Water Resources Department

February 8, 2017

Re: 2016 Inspections of B Bar K Cascade Ranch Dams: Woodrat Knob (W-43); Lake Creek (L-24); Osborne (O-15) Bradshaw 1 and 2 (B-24, B-83), Frog Pond (F-30), Harrison (H-47)

Outlet structure disconnected

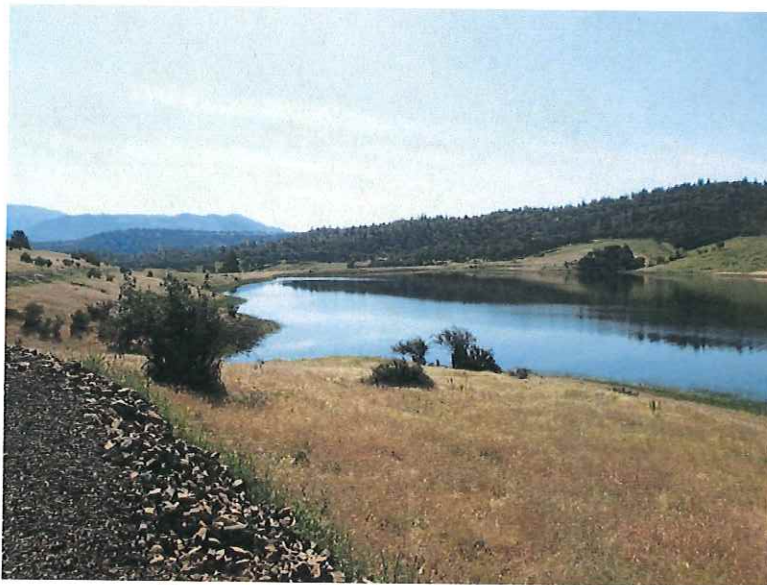
The outlet works structure is heavily overgrown, and generally disconnected from the outlet pipe. The ground in this area is always wet and poorly drained, as evidenced by the

foxtail plants that are growing all around it. The trees (red alders) are also causing damage to the outlet structure.

Reservoir with dam in background

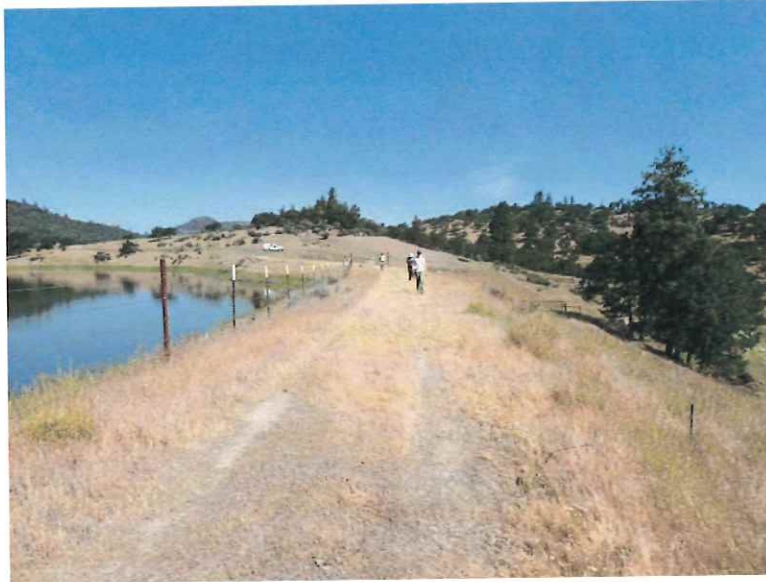
The reservoir level was 9.5 feet below the dam crest when inspected. Minimum freeboard was 6.3 feet, which is excellent. The reservoir was clean, with no logs or debris near the

dam. Both the up and downstream faces have a well maintained grass cover. The access and security at the dam are both good.
